## CITY OF TONTITOWN PLANNING OFFICE

Meeting: **June 23, 2020**  
Project: **Uncle Tanks Ph2 LSD**  
Planner: Courtney McNair, Garver

### VARIANCE REQUEST & PRELIMINARY LARGE-SCALE DEVELOPMENT PLAN

885 W. Henri de Tonti Blvd.  
Parcel # 830-37711-000

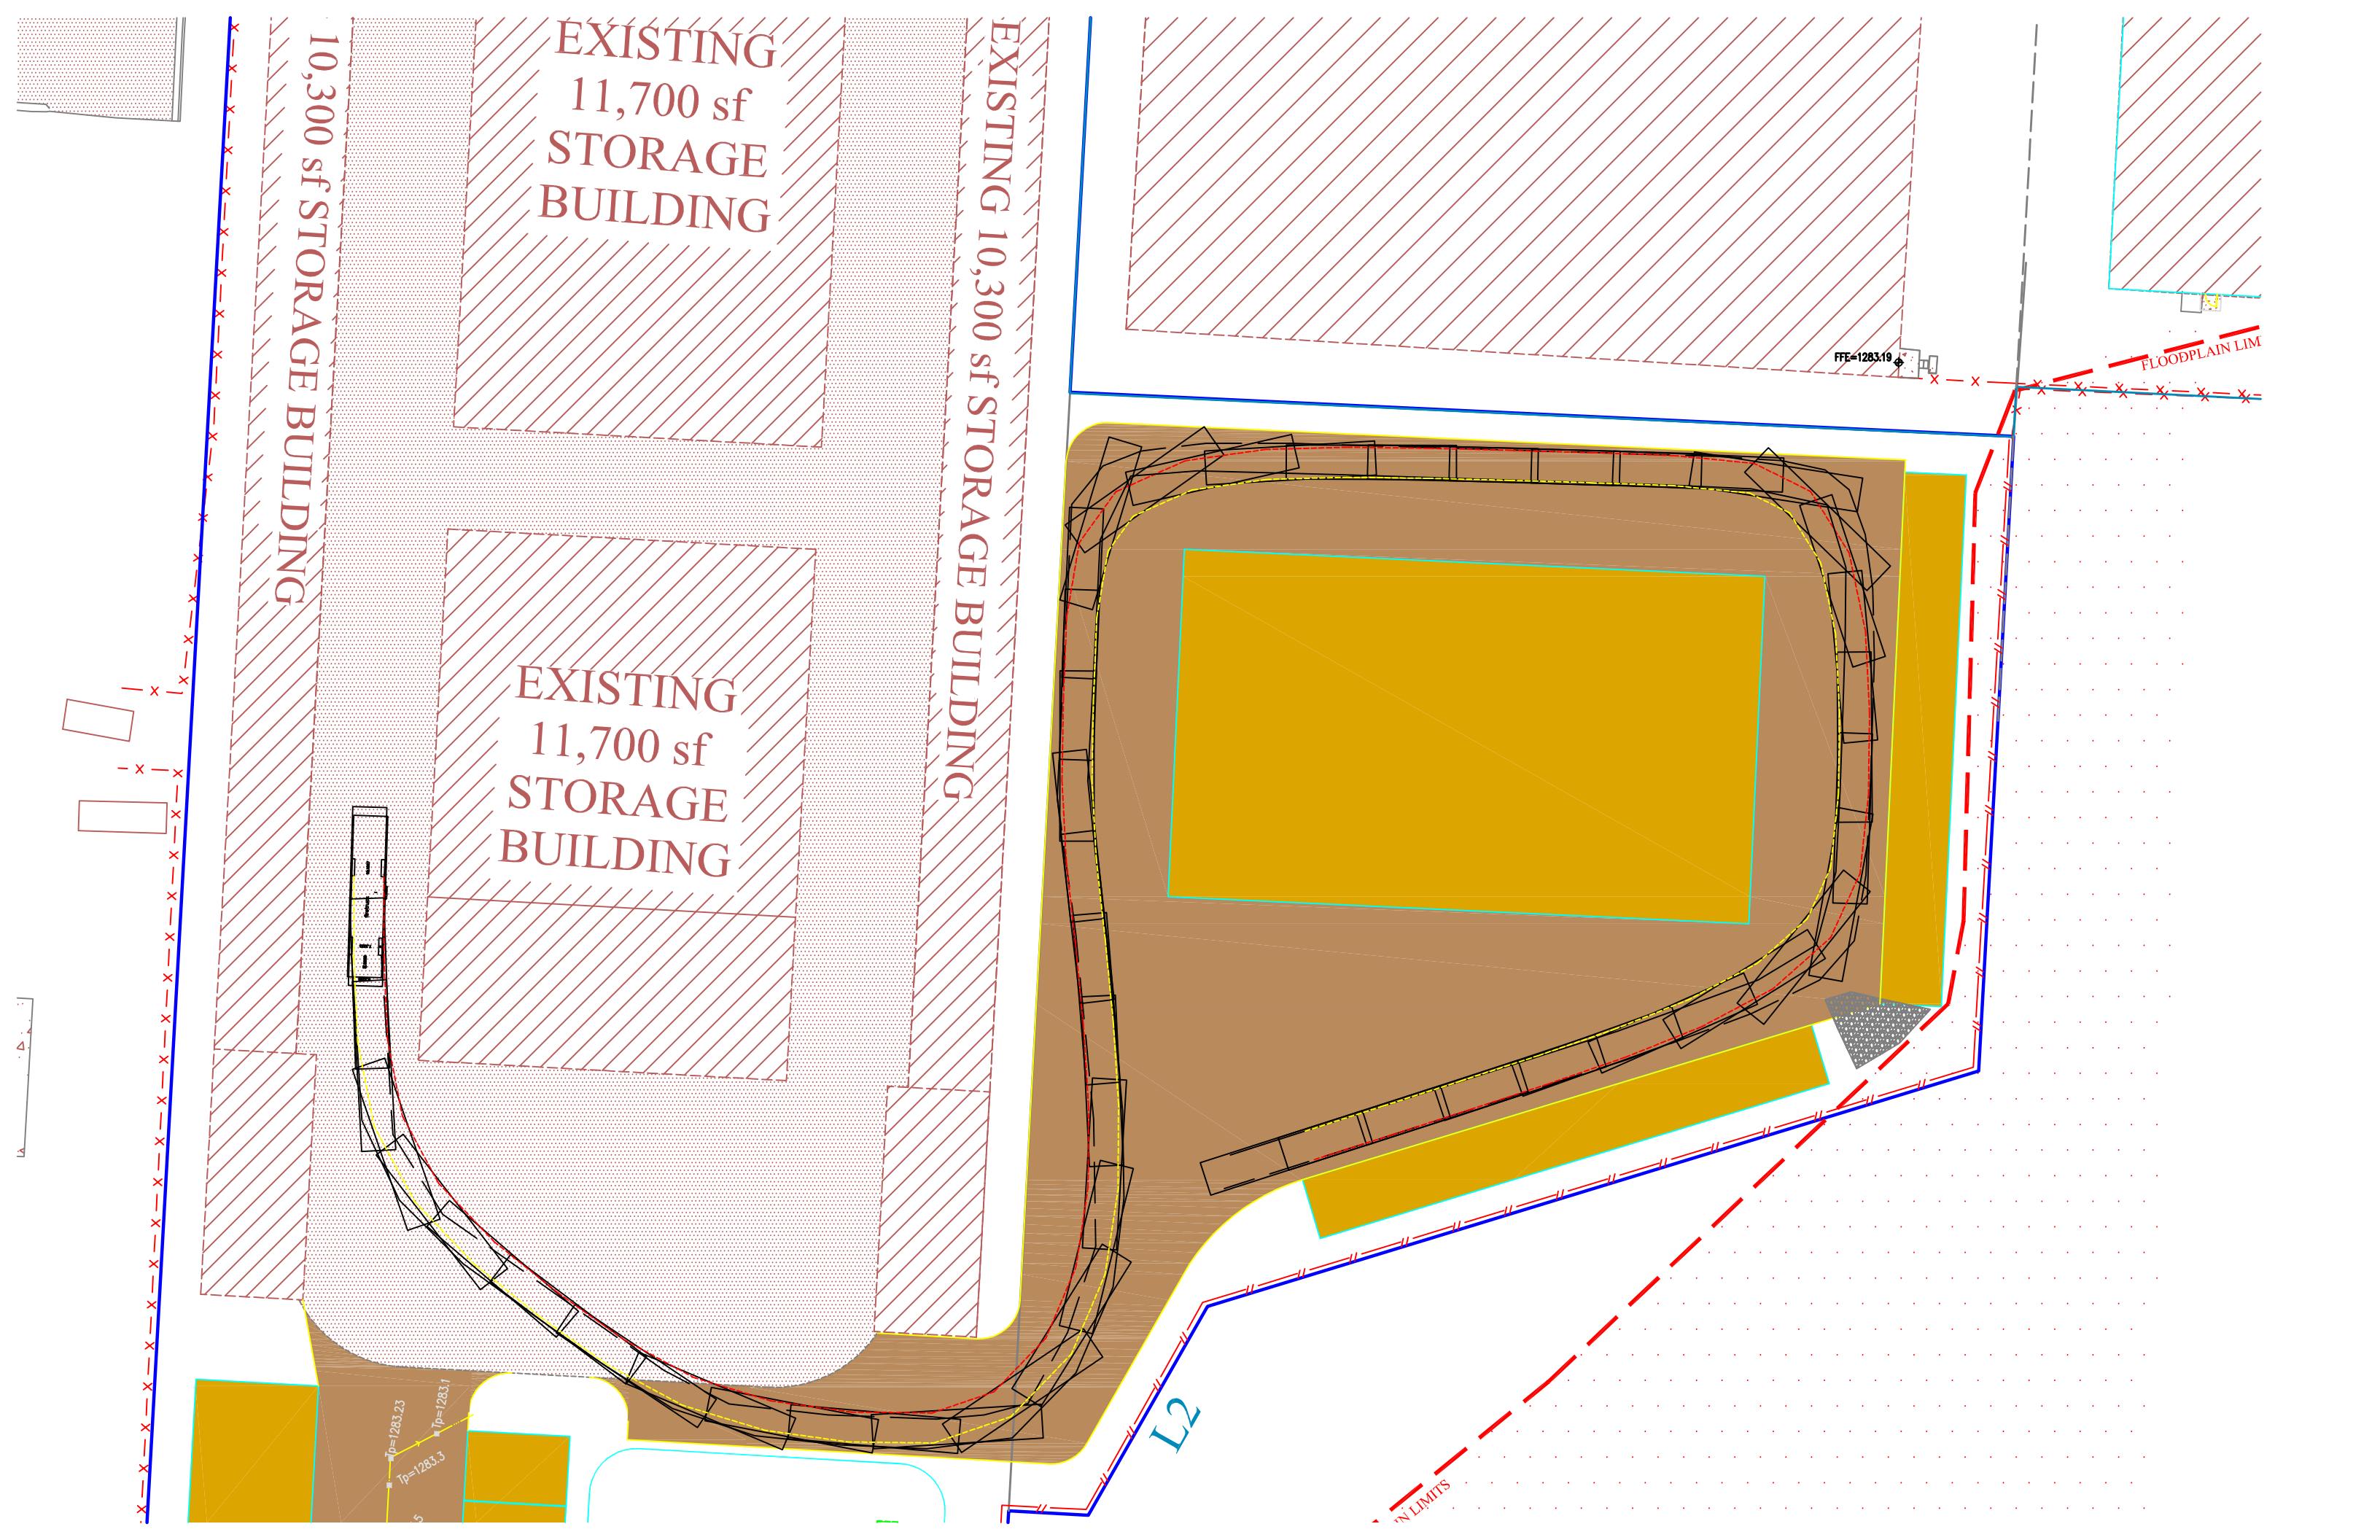
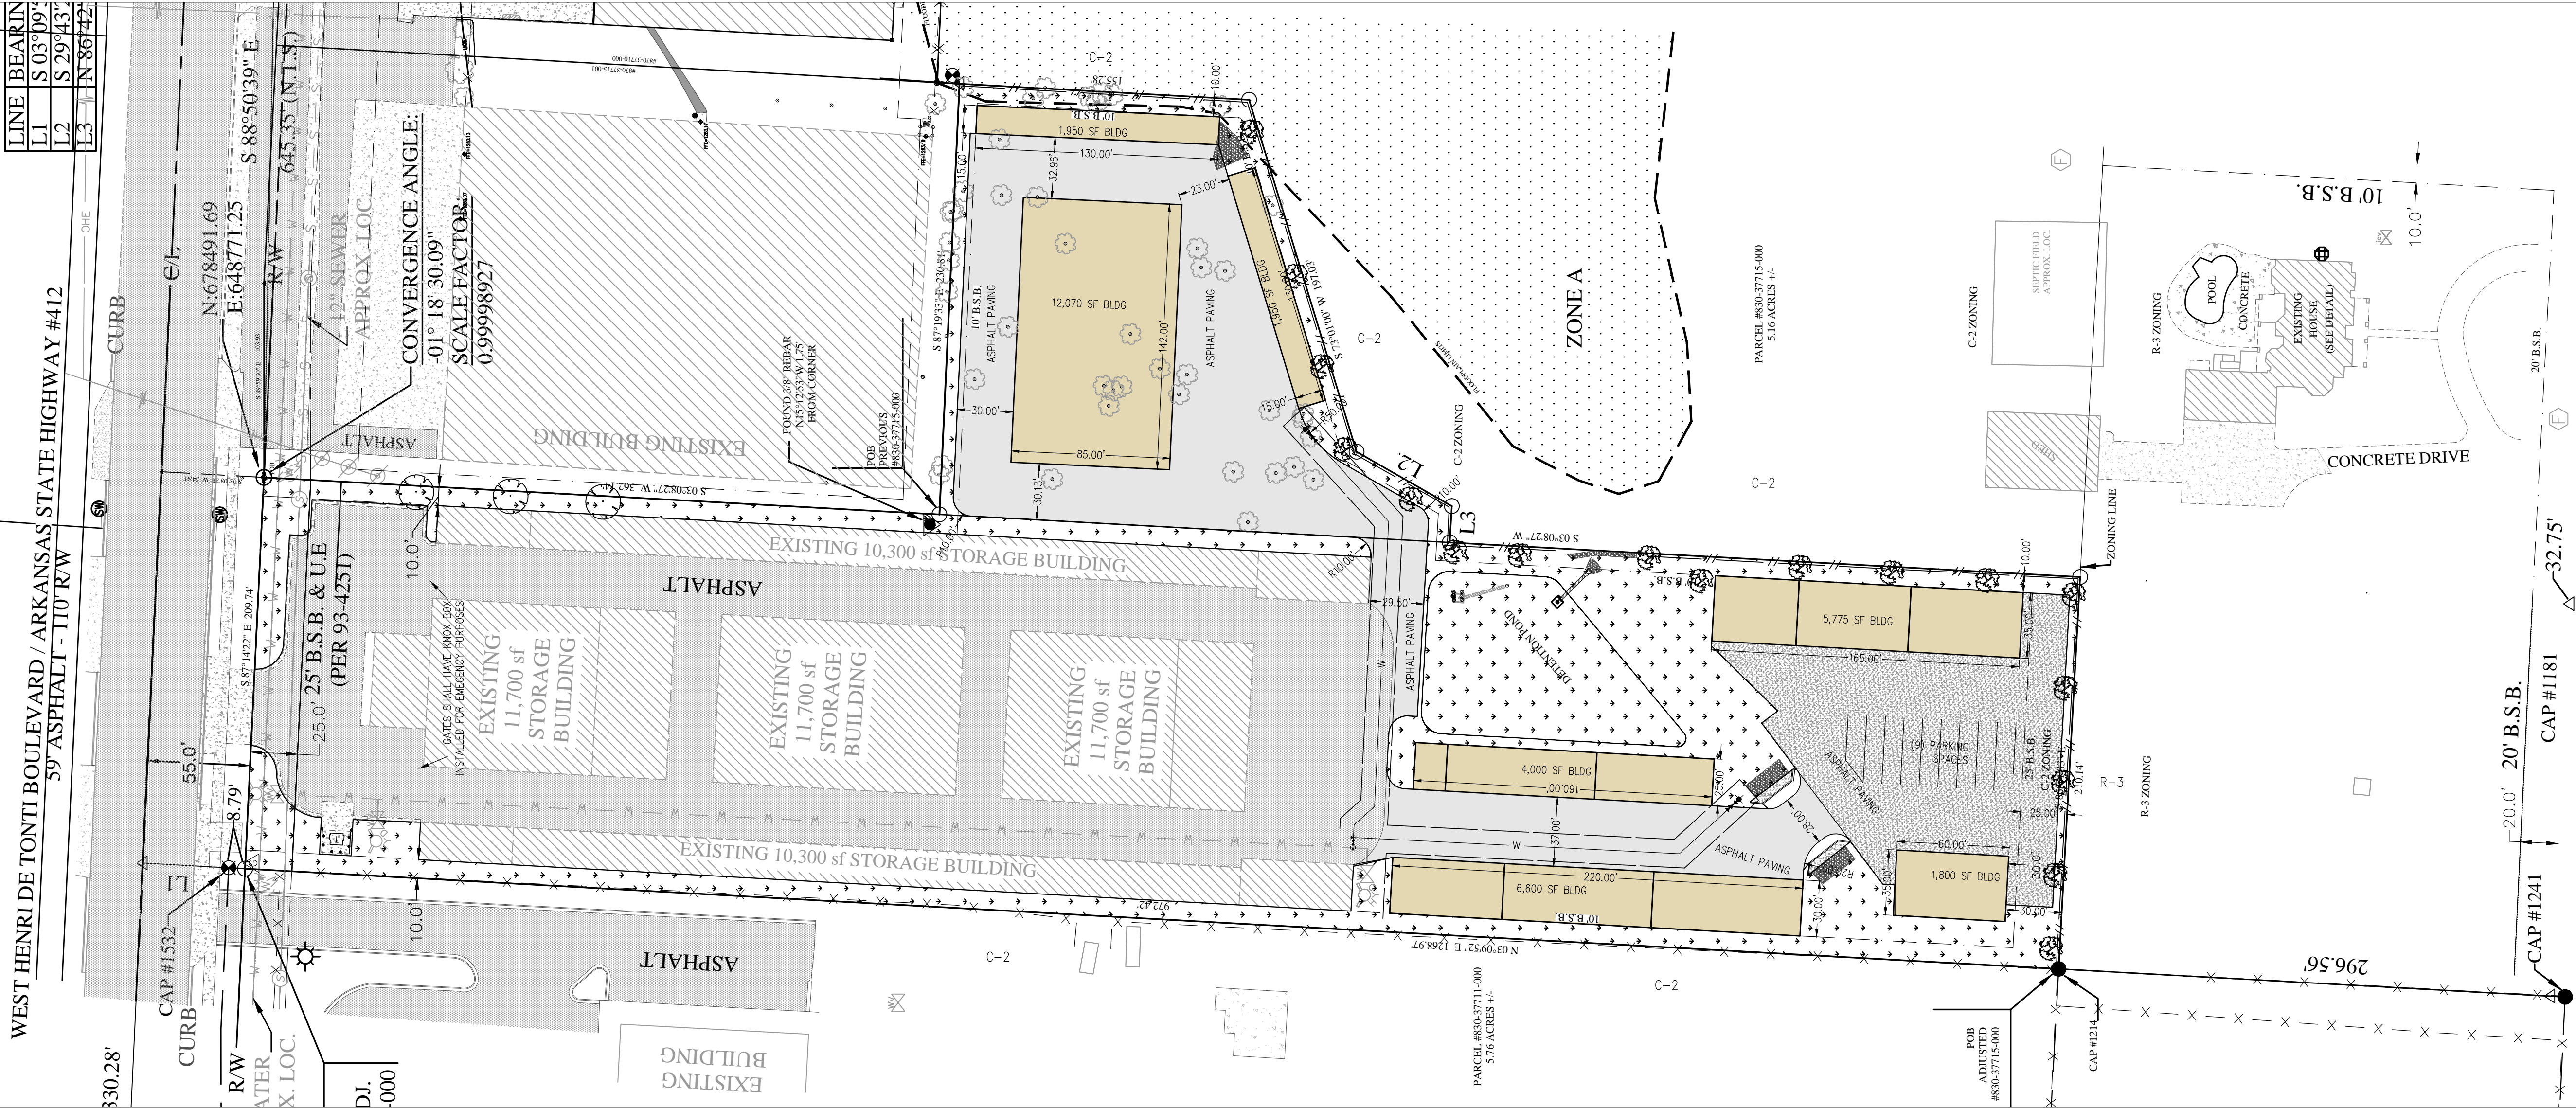
The connection to the southern units will flood in most storm events. As this is a private drive, it will be allowed. However, the Fire Marshal has required that this be noted on the plans. Signage is also required to be posted on site.

In regards to the comments about water accumulation on the roadway, this decision has been heavily contemplated as an issue for the fire department. As Fire Marshal, I **will** approve the plans for the issued Uncle Tank's project with. The contingency of this approval comes with the acknowledgment from all parties, especially the owner and engineer, that in the event of an emergency, fire department and ems operations could potentially be hindered if access is not attainable. It is understood and expected that the owner will repair any damage on the road especially damage caused by flooding or erosion. This contingency approval shall be documented on approved hard copies submitted.

FIRE DEPARTMENT NOTE:  
THIS APPROVAL COMES WITH THE ACKNOWLEDGMENT FROM ALL PARTIES, ESPECIALLY THE OWNER AND ENGINEER, THAT IN THE EVENT OF AN EMERGENCY, FIRE DEPARTMENT AND EMS OPERATIONS COULD POTENTIALLY BE HINDERED IF ACCESS IS NOT ATTAINABLE.

IT IS UNDERSTOOD AND EXPECTED THAT THE OWNER WILL REPAIR ANY DAMAGE ON THE ROAD ESPECIALLY DAMAGE CAUSED BY FLOODING OR EROSION.
